VIRGINIA ELECTRIC AND POWER COMPANY
SURRY POWER STATION UNITS 1 AND 2
SIX-MONTH STATUS REPORT IN RESPONSE TO MARCH 12, 2012 COMMISSION
ORDER MODIFYING LICENSES WITH REGARD TO REQUIREMENTS FOR
MITIGATION STRATEGIES FOR BEYOND-DESIGN-BASIS EXTERNAL EVENTS
(ORDER NUMBER EA-12-049)

**Six Month Status Report for the Implementation of Order EA-12-049
Order Modifying Licenses with Regard to Requirements for Mitigation Strategies for
Beyond-Design-Basis External Events**

**Surry Power Station Units 1 and 2
Virginia Electric and Power Company (Dominion)**

FIGURE 3 (AUGUST 2013 UPDATE)
 CORE COOLING AND DECAY HEAT REMOVAL
 PRIMARY AND ALTERNATE MECHANICAL CONNECTIONS
 SURRY POWER STATION

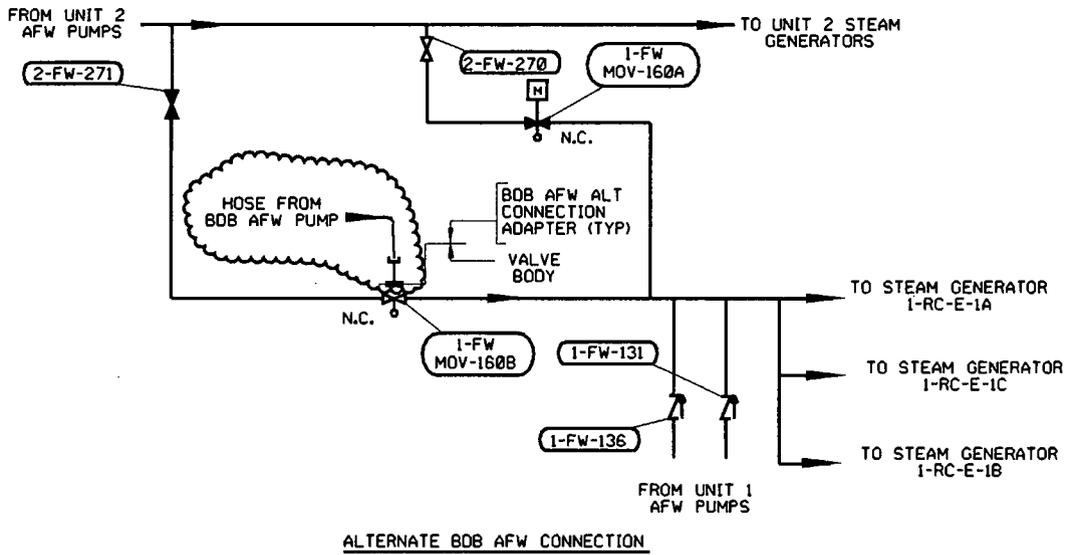
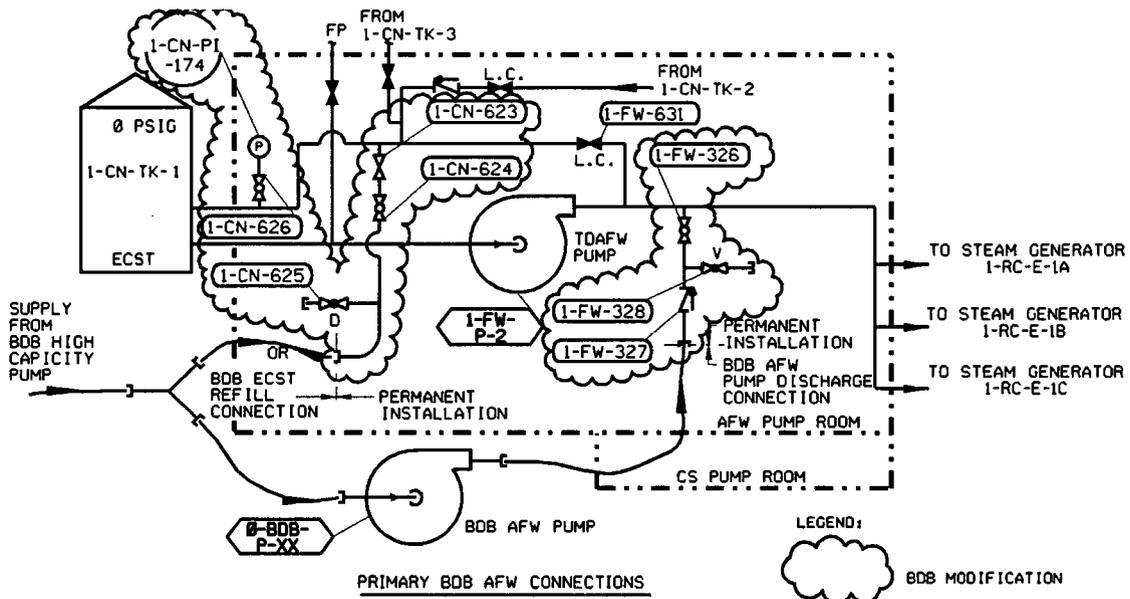
- a) Details of the alternate connection strategy for Auxiliary Feedwater (AFW) injection, as described in Section B.2 – PWR Portable Equipment Phase 2 and shown on OIP Figure 3, have changed for Surry Units 1 and 2. The tie-in locations at valve 1-FW-57 (Unit 1) and 2-FW-57 (Unit 2) will no longer be used as the alternate AFW injection connections. The re-located connections described below are more readily accessible and serve the same function in the alternate strategy.

For Unit 1, the bonnet assembly of the AFW cross-connect isolation motor-operated valve (MOV) 1-FW-MOV-160B, located in the Unit 2 AFW Pump House, will be removed and a flanged temporary hose connection adapter will be installed on the valve to support connecting the BDB AFW pump to the Unit 1 AFW cross-connect line. The location of 1-FW-MOV-160B allows for easy hose routing and is within a safety related structure.

For Unit 2, the bonnet assembly of the AFW cross-connect isolation MOV 2-FW-MOV-260B, located in the Unit 1 AFW Pump House, will be removed and a flanged temporary hose connection adapter will be installed on the valve to support connecting the BDB AFW pump to the Unit 2 AFW cross-connect line. The location of 2-FW-MOV-260B allows for easy hose routing and is within a safety related structure.

A revised OIP Figure 3 is attached. This figure represents the Unit 1 configuration only but is typical for both units.

FIGURE 7 (AUGUST 2013 UPDATE)
 BDB FLEX STRATEGY ELECTRICAL CONNECTIONS
 ONE LINE DIAGRAM
 SURRY POWER STATION

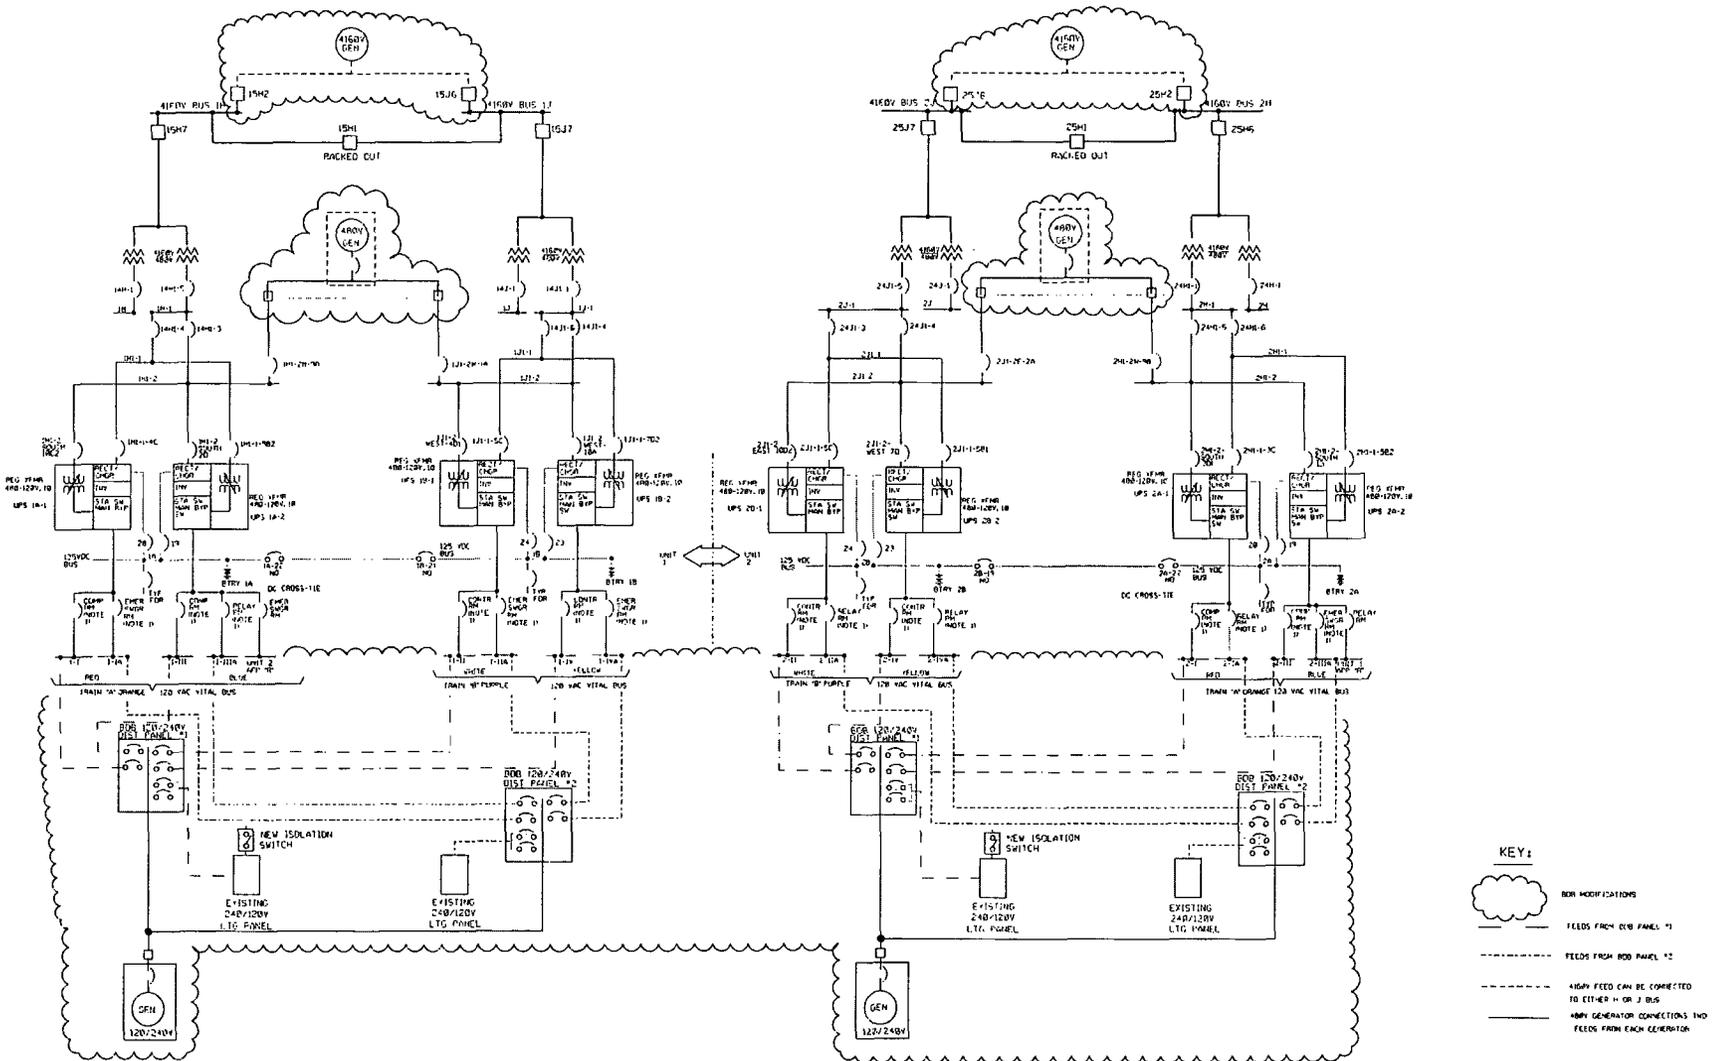
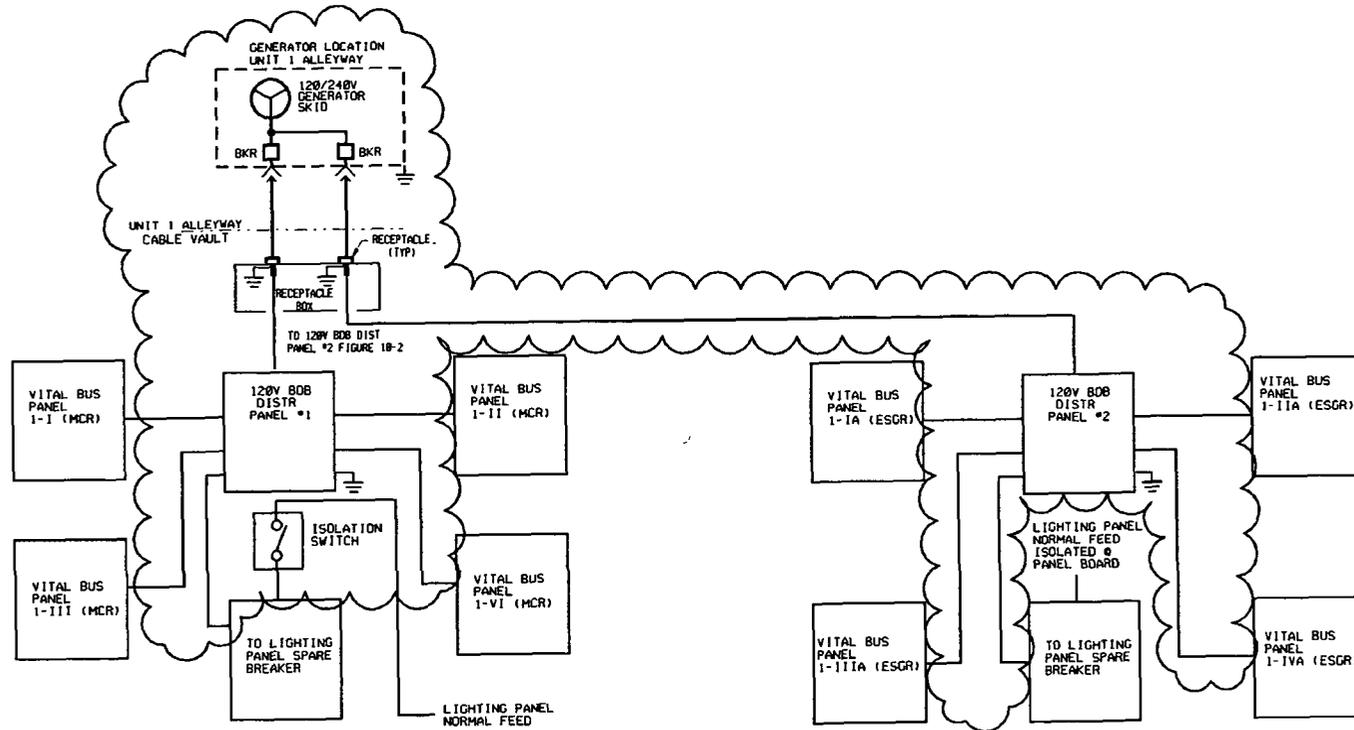
- b) Details of the strategy for the portable diesel generators (DGs) used to re-power the 120VAC vital bus circuits, as described in Section F1.2 – PWR Portable Equipment Phase 2, have changed for Surry Units 1 and 2. A single 120/240VAC DG per unit will be sized to accommodate the necessary electrical loads for that unit and will power both BDB distribution panels for that unit. Thus, the deployment of two 120/240 VAC DGs per unit as shown in Figure 7 of the previously submitted OIP is no longer being pursued, and a revised Figure 7 is attached. Figure 8 is not revised since the single 120/240VAC DG location is the same as the two DGs for each unit as stated in the OIP. Figure 9 was a typical schematic of the connections from one of two 120/240VAC DGs. A revised Figure 9 showing the current connections for the 120/240VAC DG (Unit 1 only) is attached. A spare 120/240VAC DG will be purchased; however, as stated in the OIP, the 480VAC DG is considered the alternate re-powering source for instrumentation.
